# UNITED STATES PATENT AND TRADEMARK OFFICE

10/812,907

**Office Action Summary**

## DETAILED ACTION

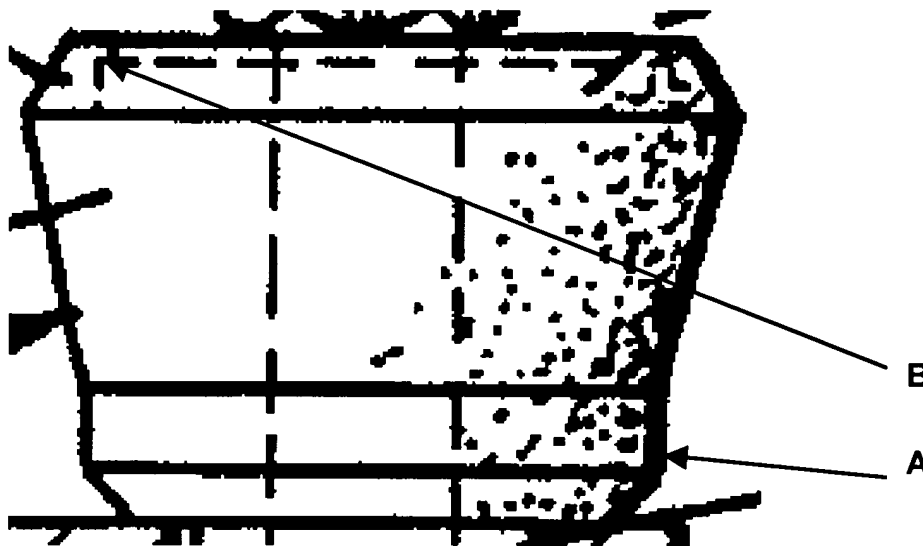
As to claim 28, Hardy, Jr. et al. disclose a grommet suitable for use in a link for connecting a pair of spaced members **102,108** having a set of aligned holes, together, generally including a bolt **112,122** having a pair of spaced upset portions **126,128**, a pair of inner **138,140** and outer **134,136** grommets disposed at each end of the bolt, engaging therebetween one of the members, and retainer means **120,132** disposed on the ends of the bolt, comprising a body formed of a resilient material having a bore for receiving the bolt therethrough, the wall of the bore having an annular groove allowing the body to be snap-fit onto an upset portion of the bolt when mounted thereon, and a rigid washer insert **A** (Figure 3 reprinted below with annotations) molded in the body disposed adjacent the groove and having an opening aligned with the bore (Examiner notes that a specific location of the washer insert relative to the groove and the upset portion is not claimed. Examiner notes that the claim does not positively claim that the washer insert is located in the bore adjacent the groove, nor that the washer insert engages the upset portion; Figures 3-4, column 2 lines 47-49).

As to claim 3, Hardy, Jr. et al. disclose a link including a washer insert **A** molded in the inner grommet **138,140** and engageable with an upset portion **126,128** of the bolt **112,122** when the inner grommet is mounted on the bolt (Figure 3).

As to claim 9, Hardy, Jr. et al. disclose a link wherein each of the outer grommets **134,136** includes a washer **A** insert molded therein (Examiner notes that a specific location of the washer insert relative to the groove and the upset portion is not claimed. Examiner notes that the claim does not positively claim that the washer insert is located in the bore adjacent the groove, nor that the washer insert engages the upset portion; Figure 3).

As to claim 18, Hardy, Jr. et al. disclose a link wherein each of the outer grommets **134,136** includes a bore for receiving the bolt **112,122** therethrough, and the wall of the bore is provided with a protrusion **B** engageable with the bolt **122** extending through the bore, functional to permit the outer grommet to be temporarily frictionally

held on an end of the bolt for shipping purposes (protrusion **B** frictionally engages bolt **122**; Figure 3).

Examiner disagrees. As to claims 1,20 and 54, Hardy, Jr. et al. disclose a link comprising a bolt **112,122** having a pair of upset portions **126,128** spaced inwardly relative to the end portions (elements **126,128** project radially outward from bolt **112,122** and thus define upset portions. Examiner notes that no specific structure of the upset portions has been claimed.); and a pair of inner grommets **138,140** having a portion functional to snap-fit (frictionally engaged) on one of the upset portions of the bolt (Figure 3).

Examiner disagrees. As to claims 4,9,20 and 28, Hardy, Jr. et al. disclose a link comprising a pair of inner grommets **138,140** each having a washer insert **A** molded therein, and the washer, and a groove in the bore permitting the inner grommet to be snap-fit onto an upset portion of the bolt with the upset portion being received in the groove when the inner grommet is mounted on the bolt with the bolt extending through the bore (Examiner notes that a specific location of the washer insert relative to the groove and the upset portion is not claimed. Examiner notes that the claim does not positively claim that the washer insert is located in the bore adjacent the groove, nor that the washer insert engages the upset portion); and a pair of outer grommets **134,136** each having a washer insert **A** mounted therein, and the washer and a groove in the bore permitting the outer grommet to be snap-fit onto a flanged portion **132** of one of the nuts (Examiner notes that a specific location of the washer insert relative to the groove and the flanged portion is not claimed. Examiner notes that the claim does not positively claim that the washer insert is located in the bore adjacent the groove, nor that the washer insert engages the flanged portion; Figure 3).

Examiner disagrees. As to claim 18, Hardy, Jr. et al. disclose a link wherein the wall of the bore of each of outer grommets **134,136** is provided with a protrusion **B** engageable with the bolt **122** extending through the bore, functional to permit the outer grommet to be temporarily frictionally held on an end of the bolt for shipping purposes (protrusion **B** frictionally engages bolt **122**; Figure 3).
